Item Name: Crosstube Assembly, Mid Aft

DART AEROSPACE LTD	Work Order: 159222
Description: Crosstube Assembly, Mid Aft	Part Number: D206-667-247
Inspection Dwg: D206-667-247 Rev: A	Page 1 of 2

DRAWING NO. D206-667-247
REV. A
SHEET 1 OF 4

DRAWING NO. D206-667-247	TITLE CROSSTUBE ASS'Y (206L MID AFT)	REV. A	DART AEROSPACE LTD ENGINEERING ORDER		D.E.O. NO. D206-667-247-A-1	SHEET NO. SHEET 1 OF 1	SCALE NTS
DRAWN <i>q2</i>	CHECKED <i>ASS</i>	MFG. APPR. <i>KB</i>	APPROVED <i>AMP</i>		DE APPR. <i>HA</i>		
DATE 11.07.15	DATE 11.07.20	DATE 11.07.21	DATE 11/07/21		DATE 11.07.21

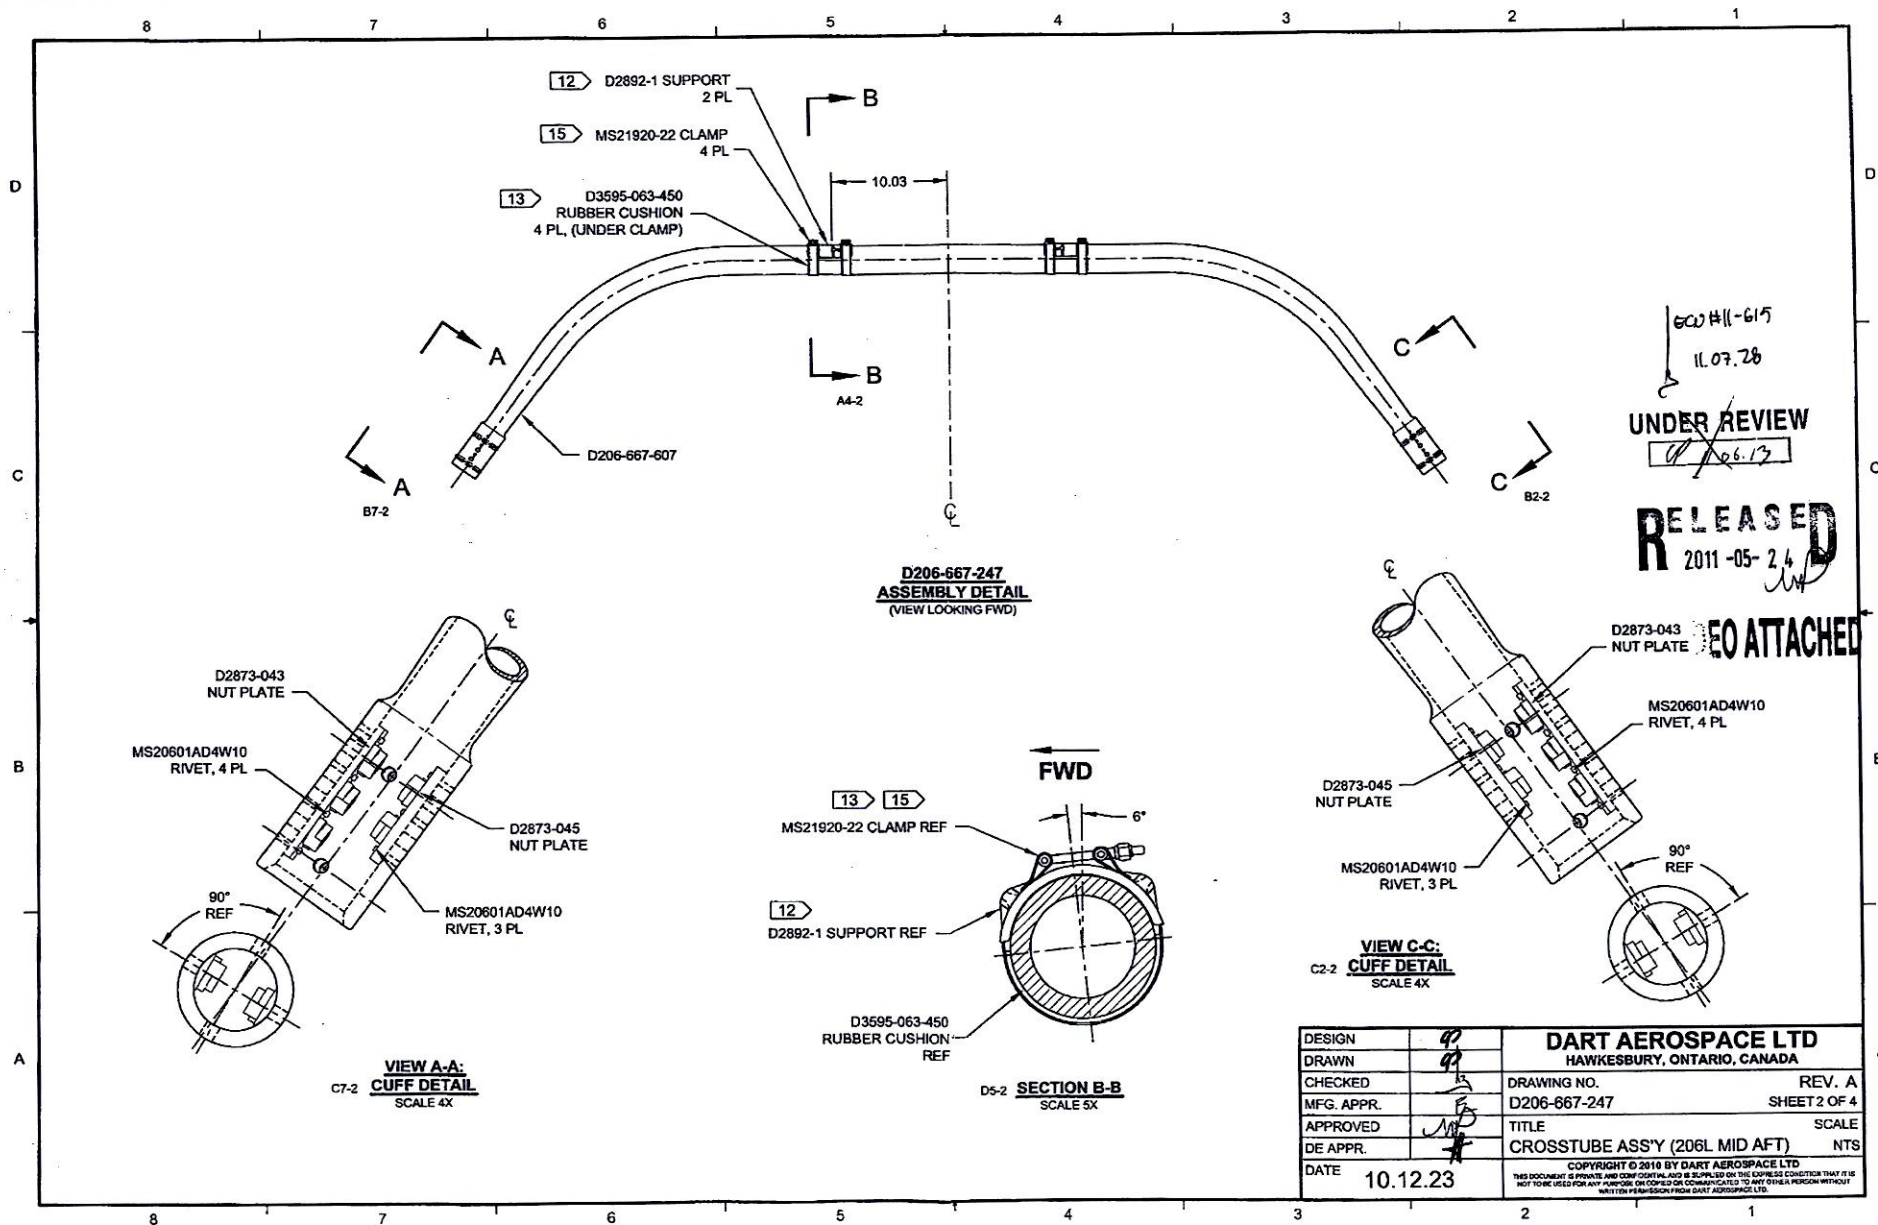
PURPOSE:

REPLACE MAGNOBOND WITH PROSEAL.

NOTE 12 & 15, SHEET 1 IS AMENDED AS FOLLOWS:

Item	Qty -247	Part Number	Description
9	A/R	PROSEAL 890 B-2	SEALANT, AMS-S-8802 CLASS B-2

- 12) TO INSTALL D2892-1 SUPPORT: ABRASE MATING SURFACE OF SUPPORT AND CROSSTUBE WITH 180-GRIT SANDPAPER AND REMOVE RESIDUE WITH MEK (OR EQUIVALENT). APPLY A 0.04" TO 0.07" THICK LAYER OF PROSEAL 890 CLASS B-2 (OR AMS-S-8802 CLASS B-2) SEALANT TO MATING SURFACE OF SUPPORT.
- 15) TORQUE CLAMPS 80 TO 100 IN-LB. ENSURE AT LEAST 1.5 THREADS SHOWING IN SAFETY AND THAT NUT HAS NOT BOTTOMED-OUT AFTER TORQUING. **PRIOR TO PACKAGING, RE-CHECK TORQUE ON CLAMPS AFTER PROSEAL 890 SEALANT HAS CURED FOR 72 HOURS.**
